OHIO DEPARTMENT OF TRANSPORTATION DIVISION OF HIGHWAYS

HAZARD ELIMINATION PROGRAM

BRIDGES TREATED BY REPAIR, RAIL & GUARD RAIL

BRIDGE NO. HOL-62-0793

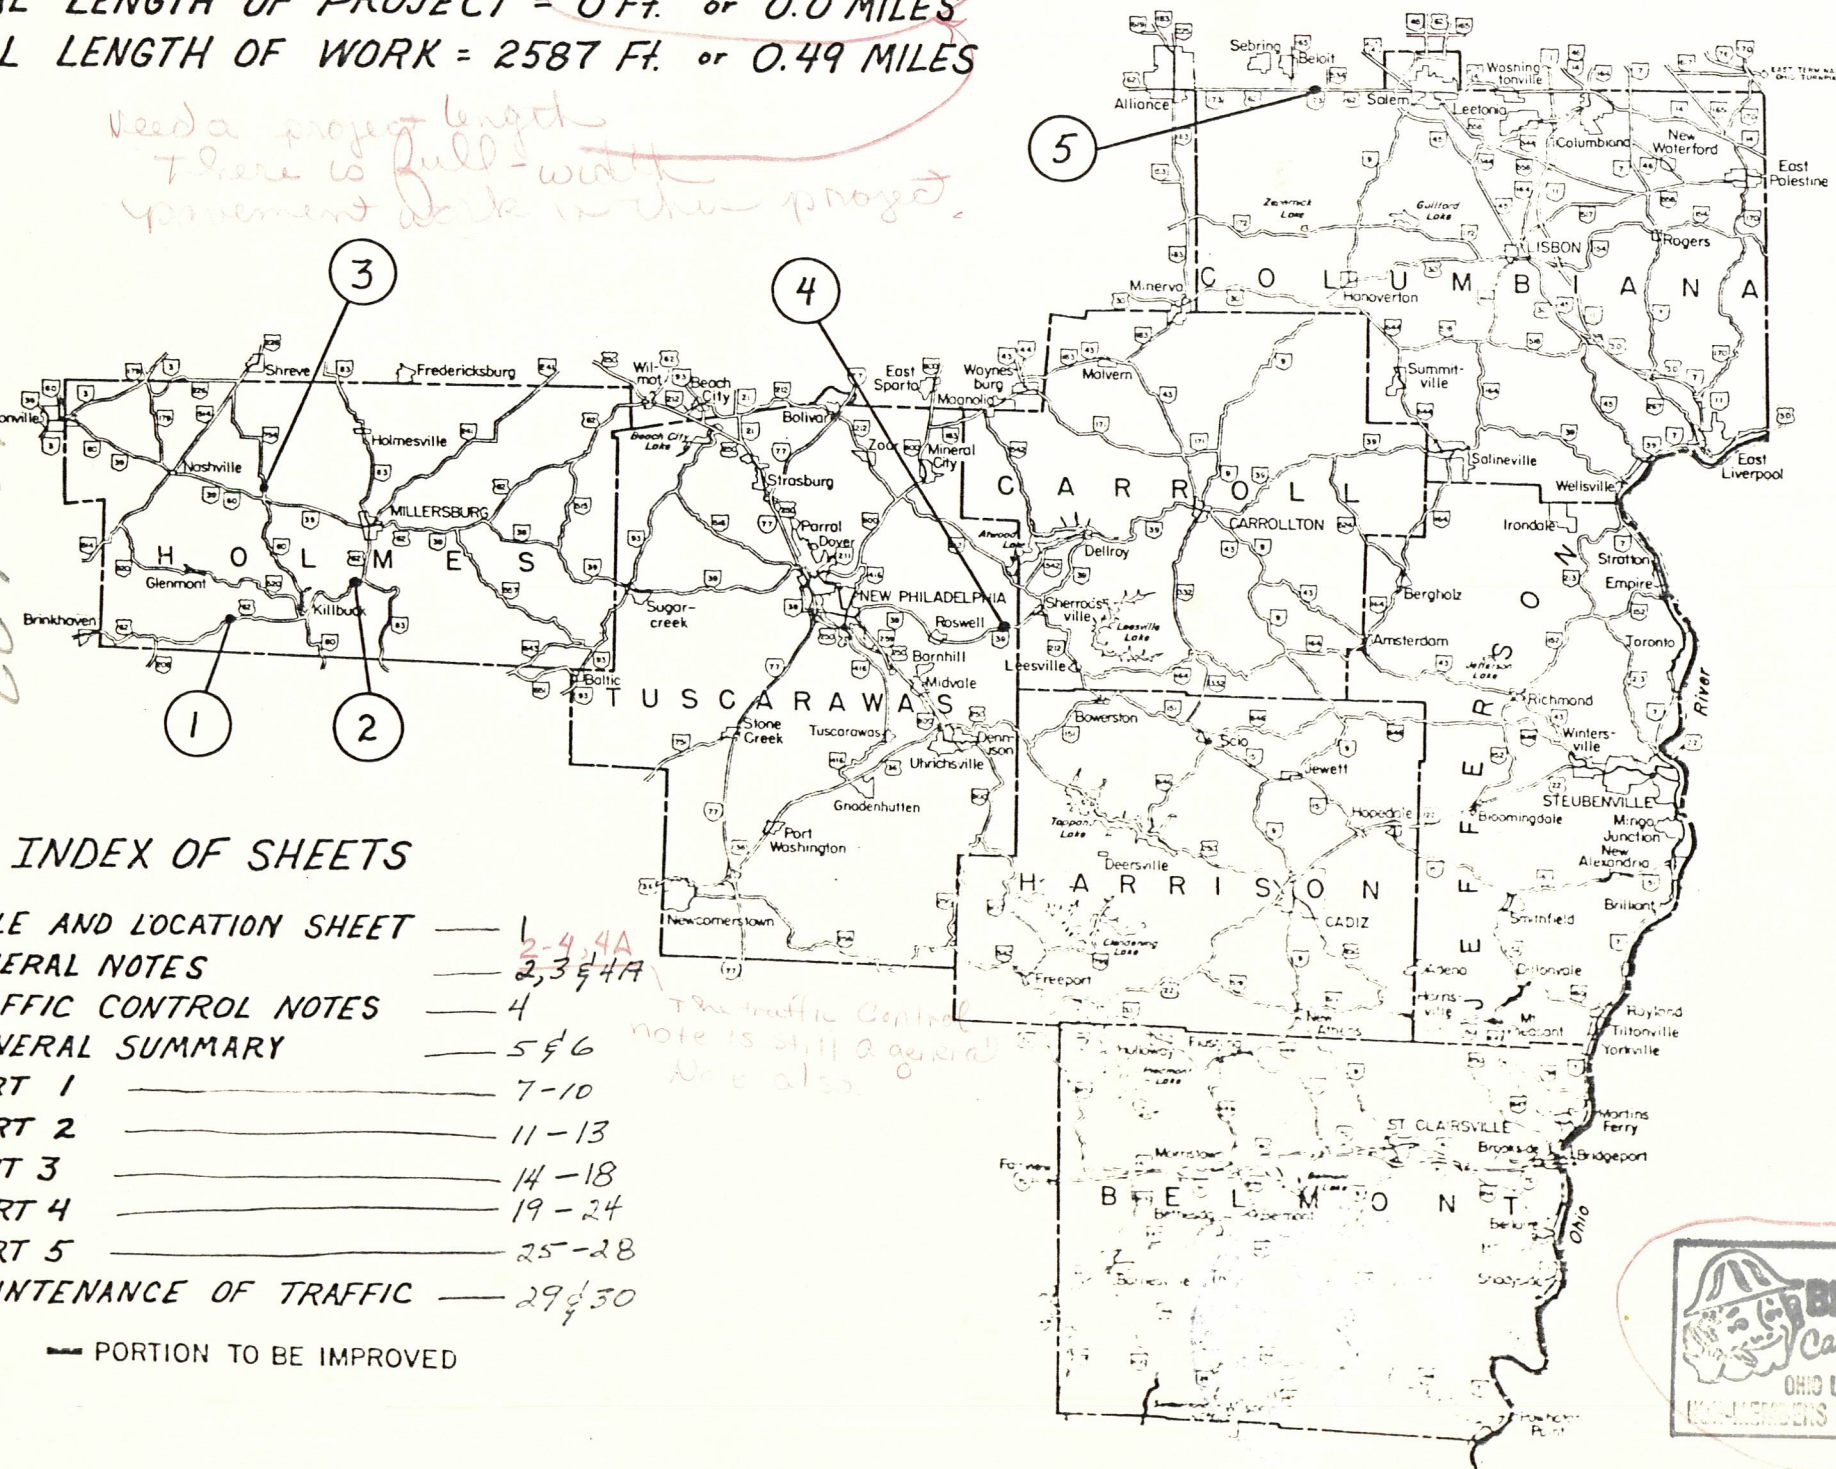
Need a project length
There is full-width
improvement work in this project.
